# SERVICE BULLETIN

**SUBJECT: NEW DS PUMP MODEL FOR MODEL YEAR 2004 GENERAL ENGINE PRODUCTS (GEP) 6.5L DIESEL ENGINE**

**PUMP MODELS AFFECTED: DS4831-5827**

Figure 1

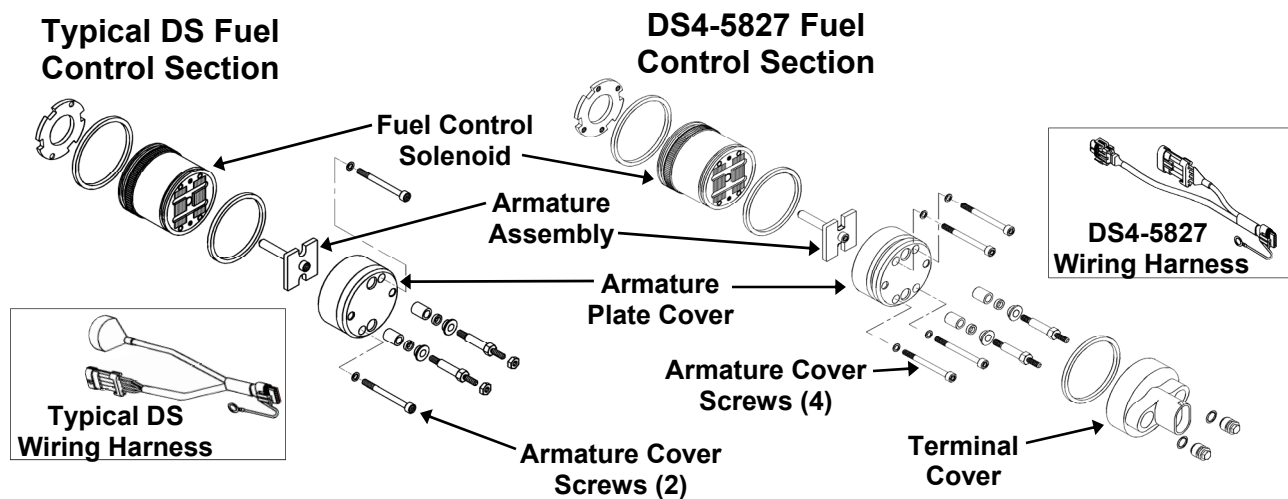
The DS4-5827 uses a different fuel control section (Reference Figure 1) and a cam ring with a slightly different pumping ramp profile. The cam ring was changed because of different fueling requirements and the fuel control section was changed for the purposes of manufacturing standardization. In addition, the engines Electronic Control Unit (ECU) employs a different pump recognition strategy for selecting the optimal fueling table.

Figure 2

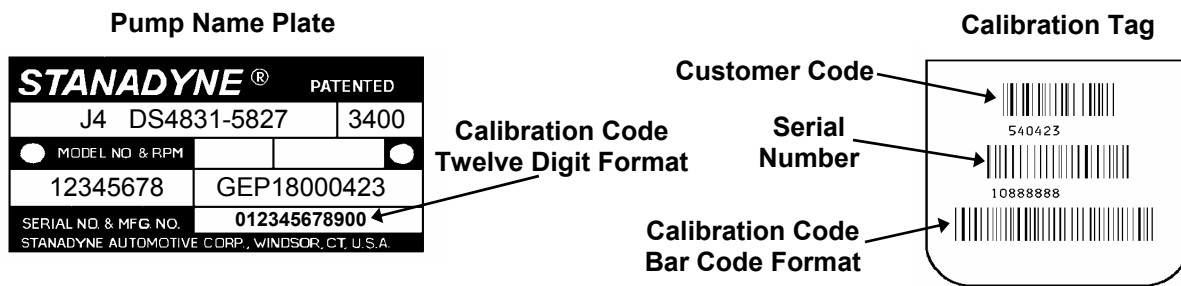
For optimized engine performance, fuel table selection within the ECU is achieved by the means of a downloaded calibration code instead of the calibration resistor recognition strategy used on other 6.5L engine applications. Because of the different fuel table selection strategy, all DS4-5827 use a number “5” calibration resistor (P/N 30896). The calibration code is created by a computer program using pump performance data generated during initial pump calibration. The calibration code is stamped onto the pump name plate in a twelve digit format (Reference Figure 2). For production purposes a bar coded calibration tag is also created (Reference Figure 2) and attached to the wires on the electric shut-off solenoid. The calibration code is downloaded to an ECU during engine production by means of a bar code reader.
